LiDAR Quality Assessment Report

SD_Missouri River Lidar Dewberry_2016_D16 - Block 8

NGTOC
2018-06-18
Sarah Klaas

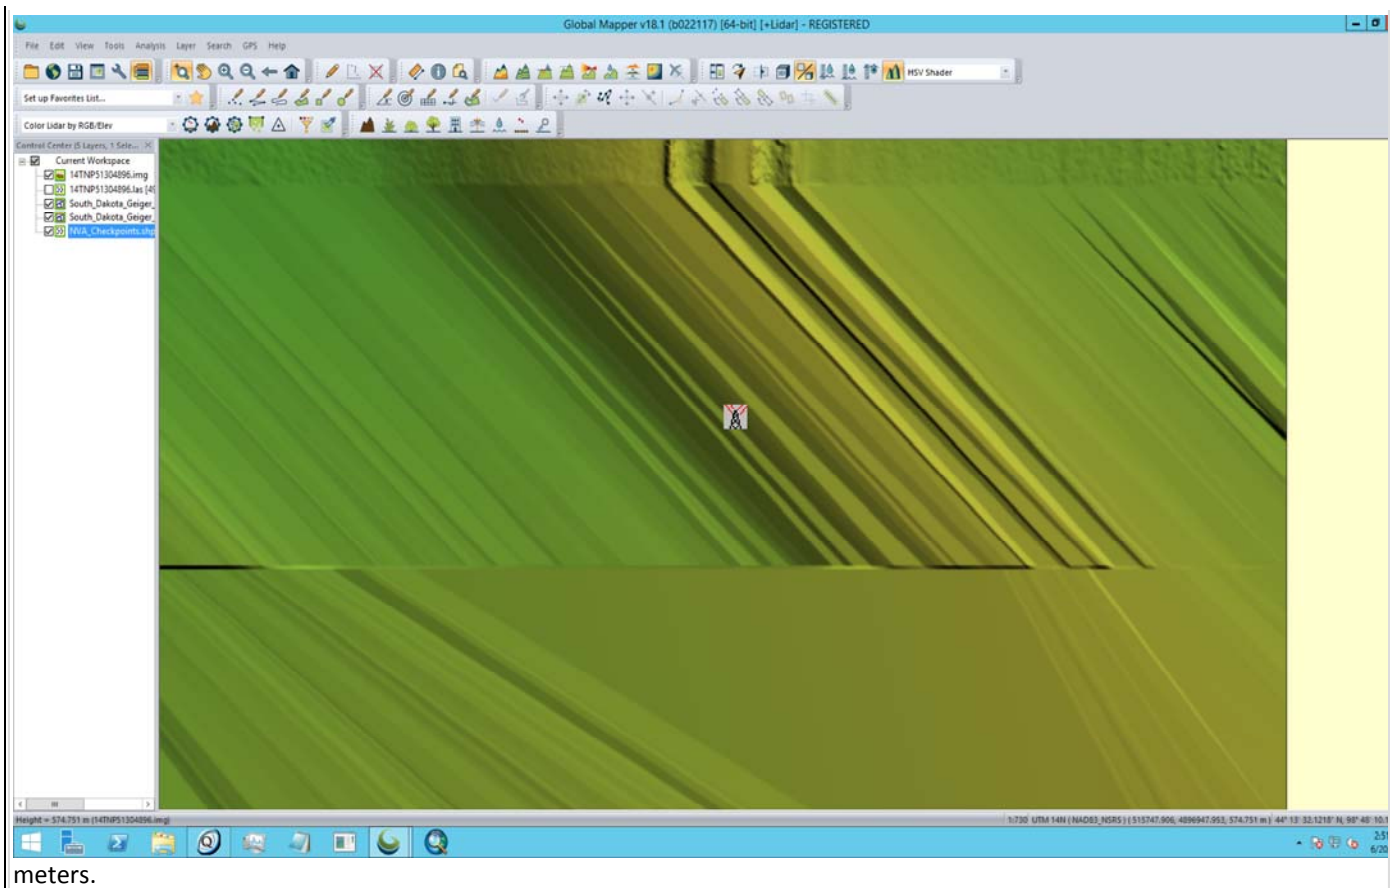
VVA testing failed to meet USGS specifications. Three of the worst points are pictured below, showing the checkpoint below the ground surface.

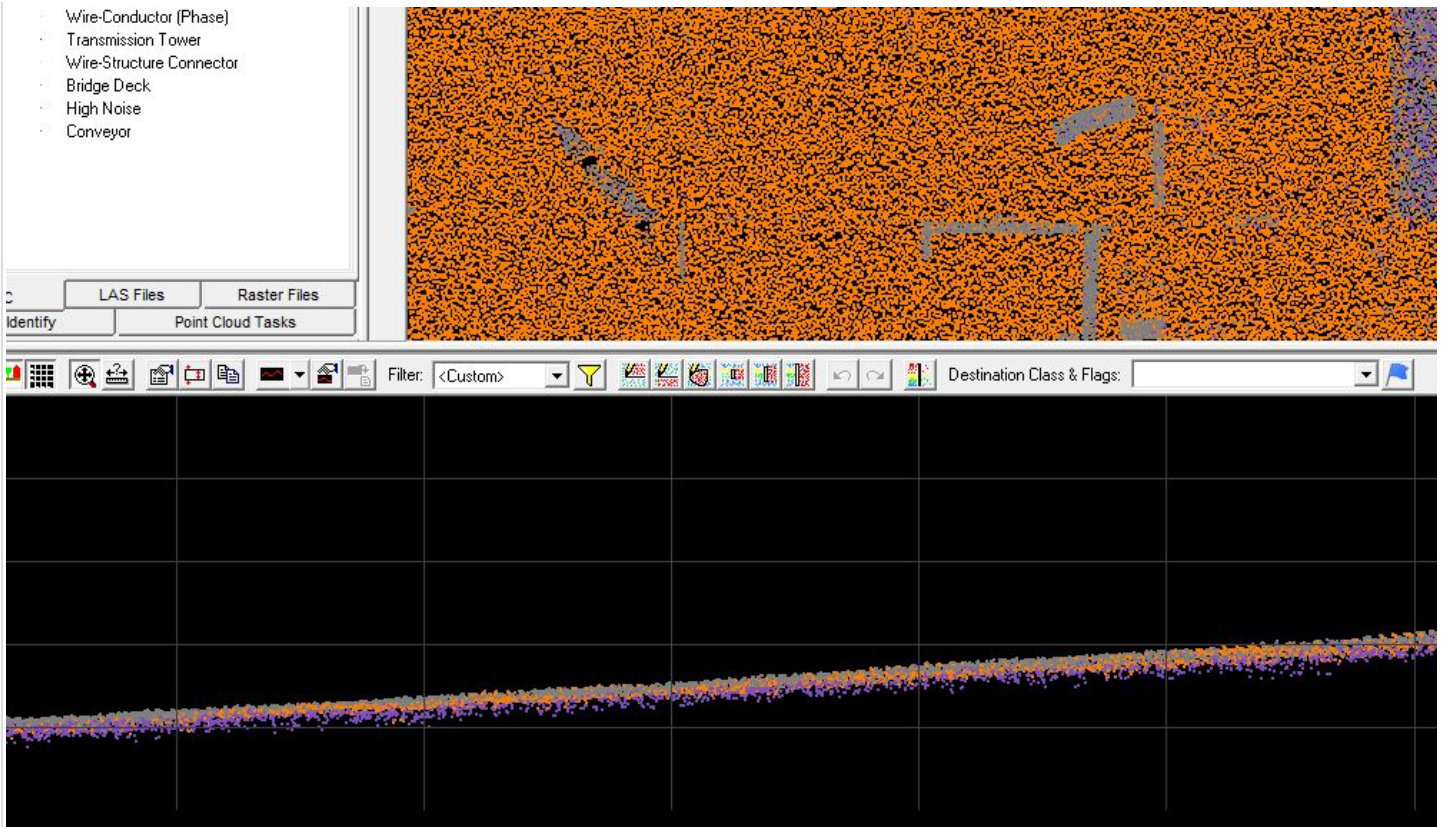
Noise and ground points in an agricultural field with probable vegetation. (6/18/18)
Vegetation Issue remains. (9/14/2018)

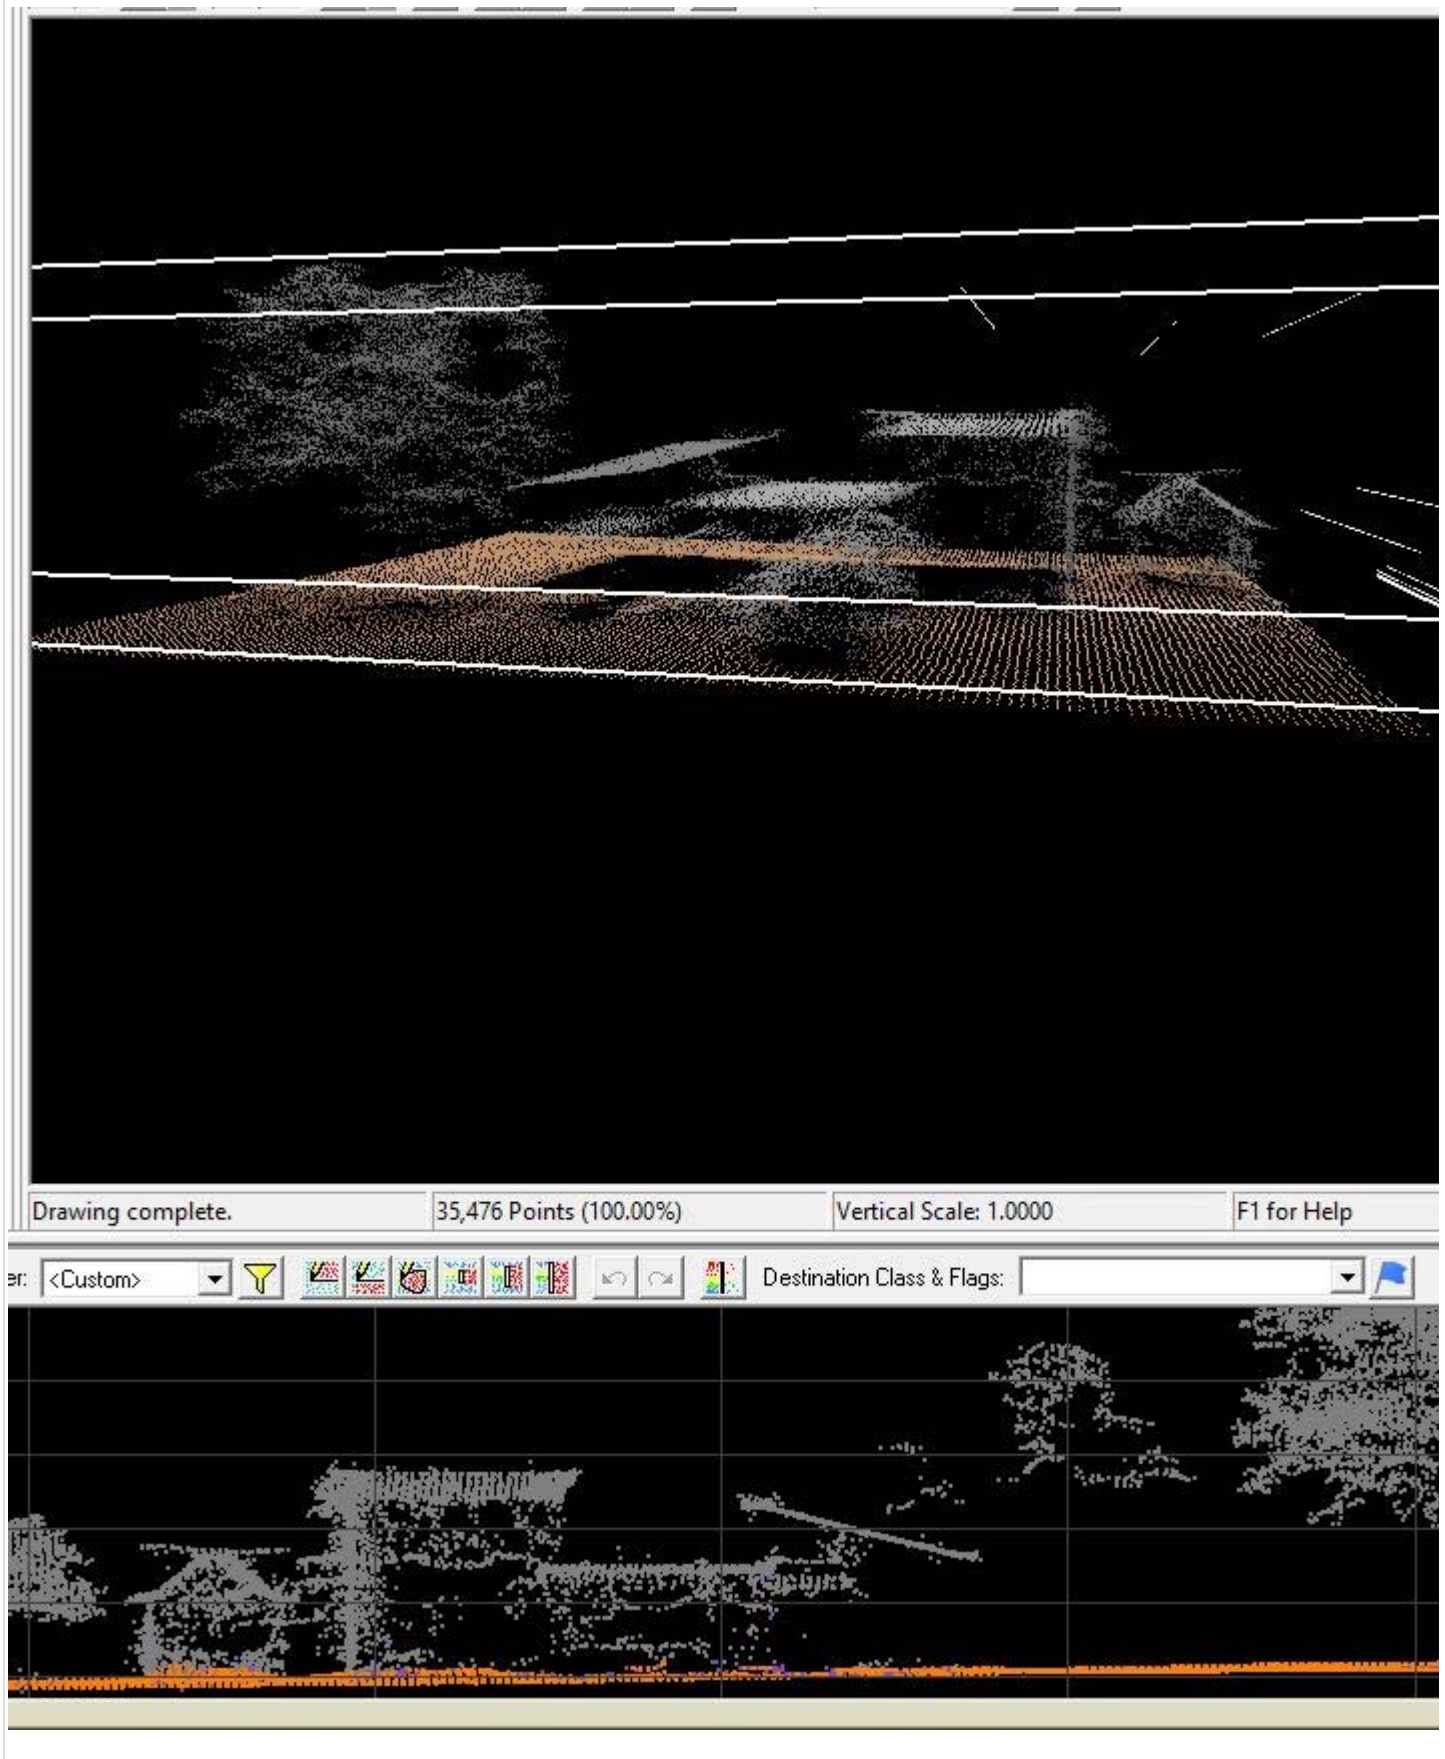
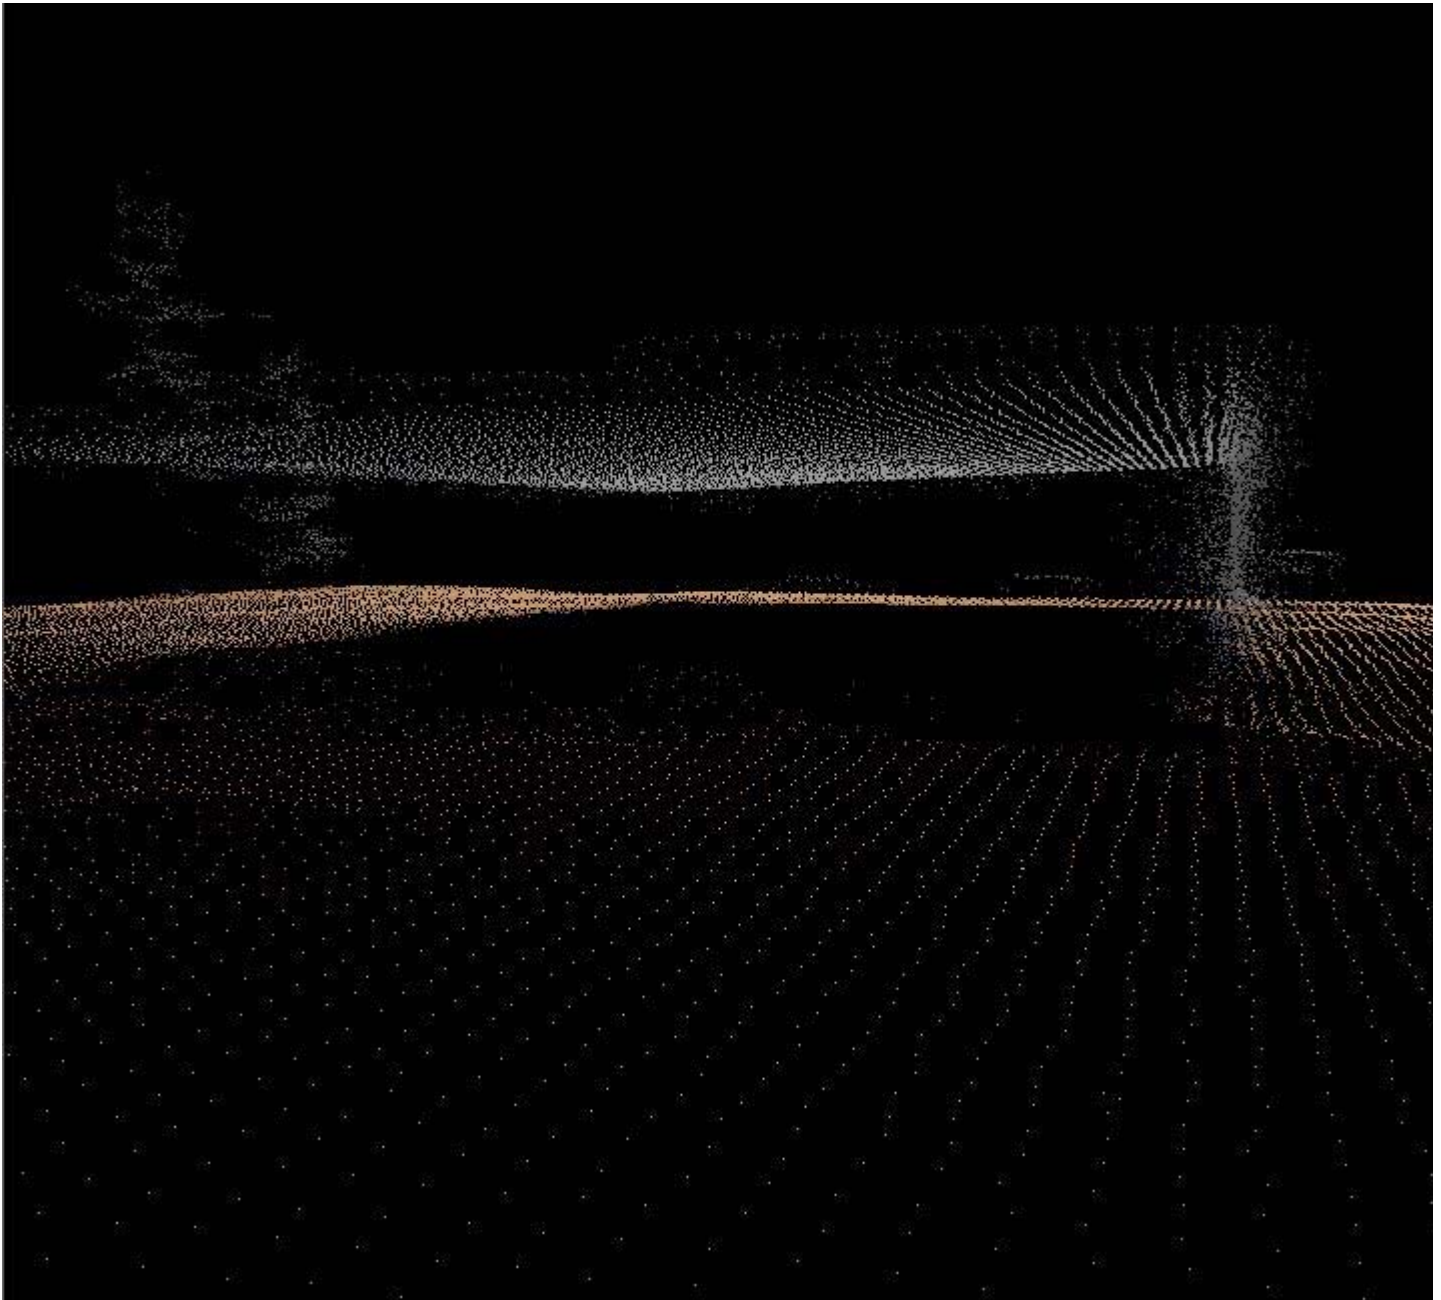
Examples of vertical wall structure scatter from the geiger mode sensor

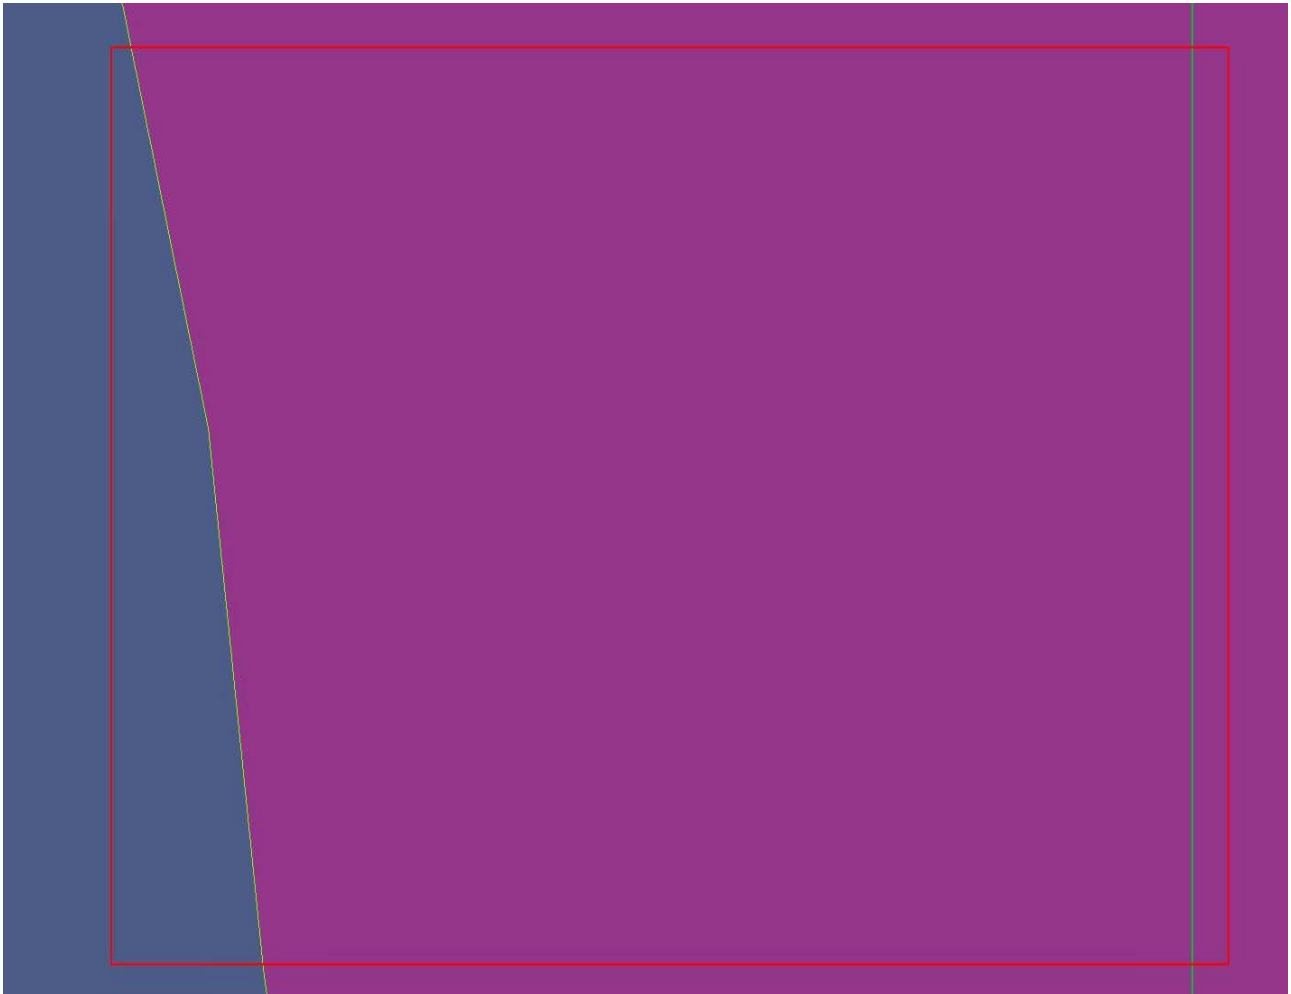
Data does not extend out to the project boundary along the Eastern and Southern extent of Block 8. (6/18/2018)

Dewberry states the data does extend to the project boundary but USGS was not delivered this boundary shapefile and can only judge based on the delivery block diagram shapefile that was delivered. Please deliver the project boundary shapefile that was used to create your data boundaries. (9/14/2018)

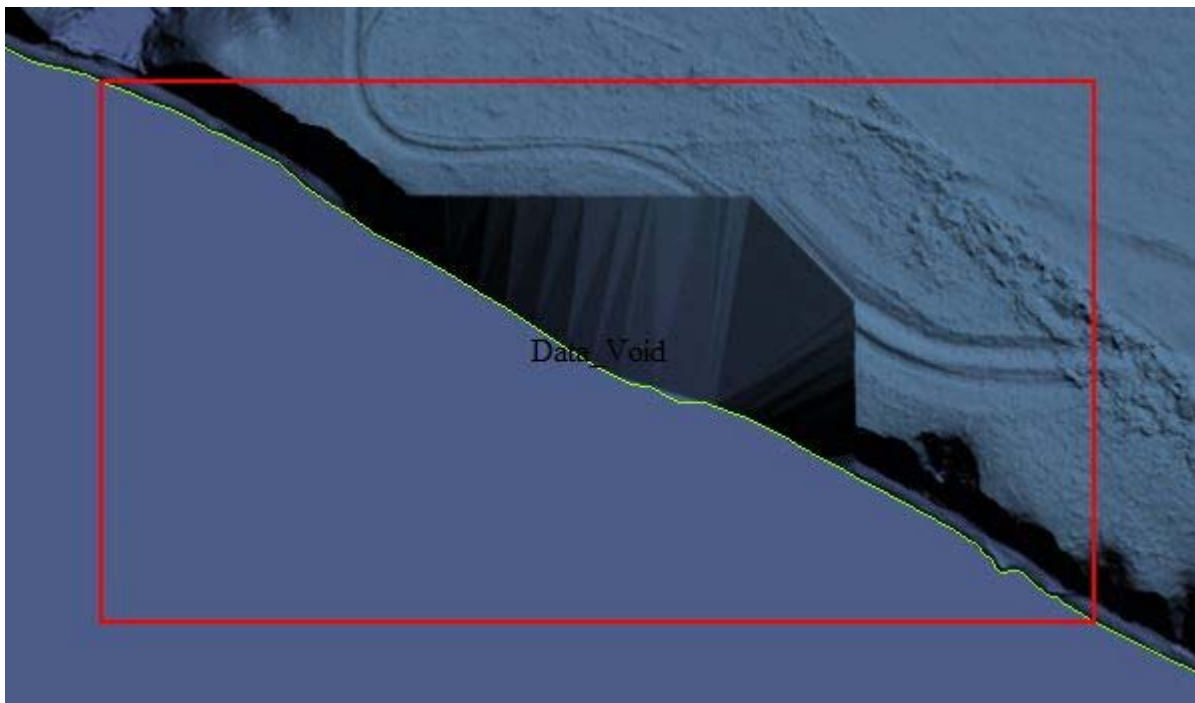
One data void along a lake in block 8 was found. (6/18/18) Corrected (9/14/2018)

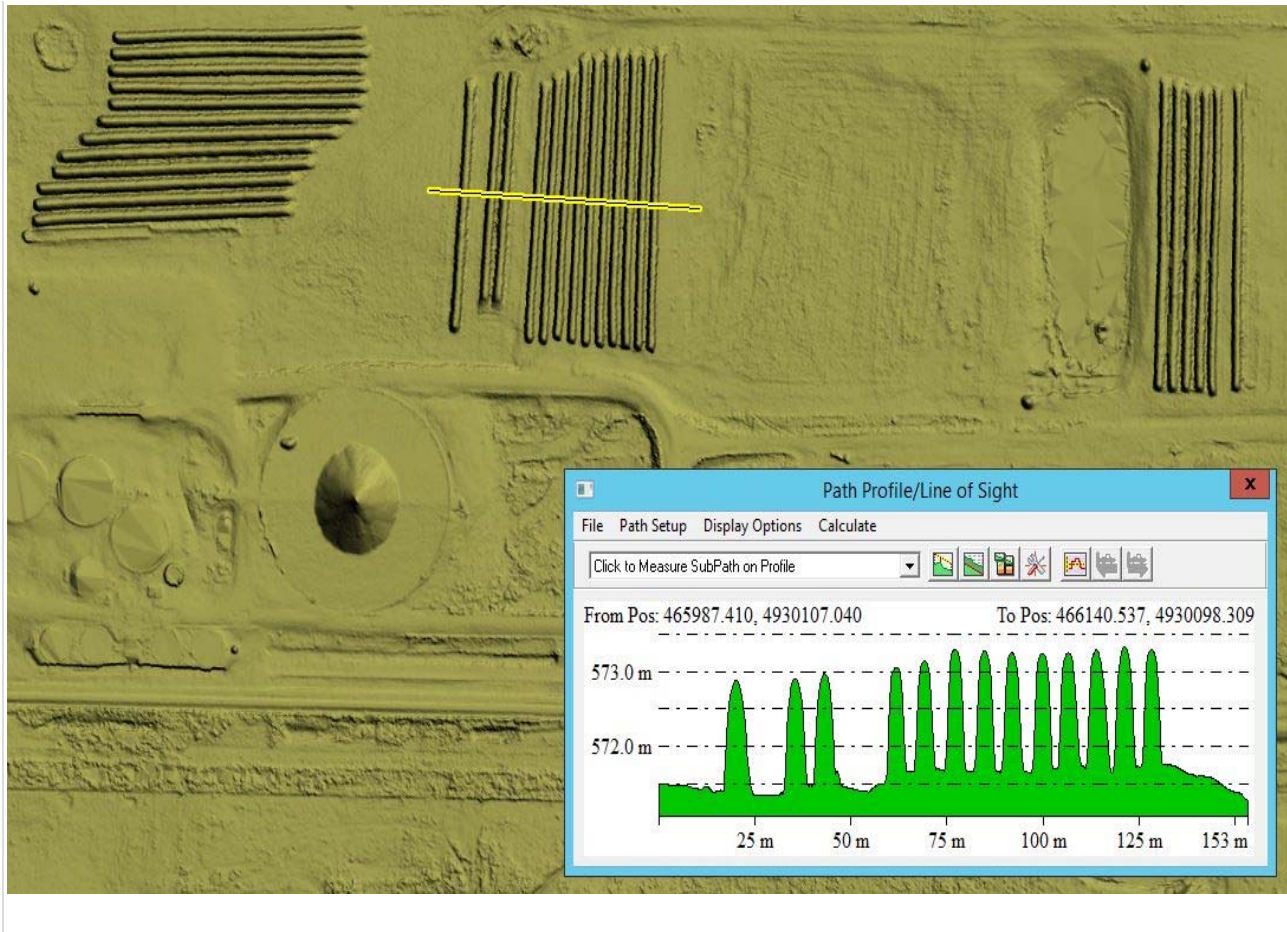
2 hydroflattening errors were found in block 8, waterbodies greater than 2 acres are not hydroflattened. Examples of this type of error can be seen below. (6/18/18) **Corrected (9/14/2018)**
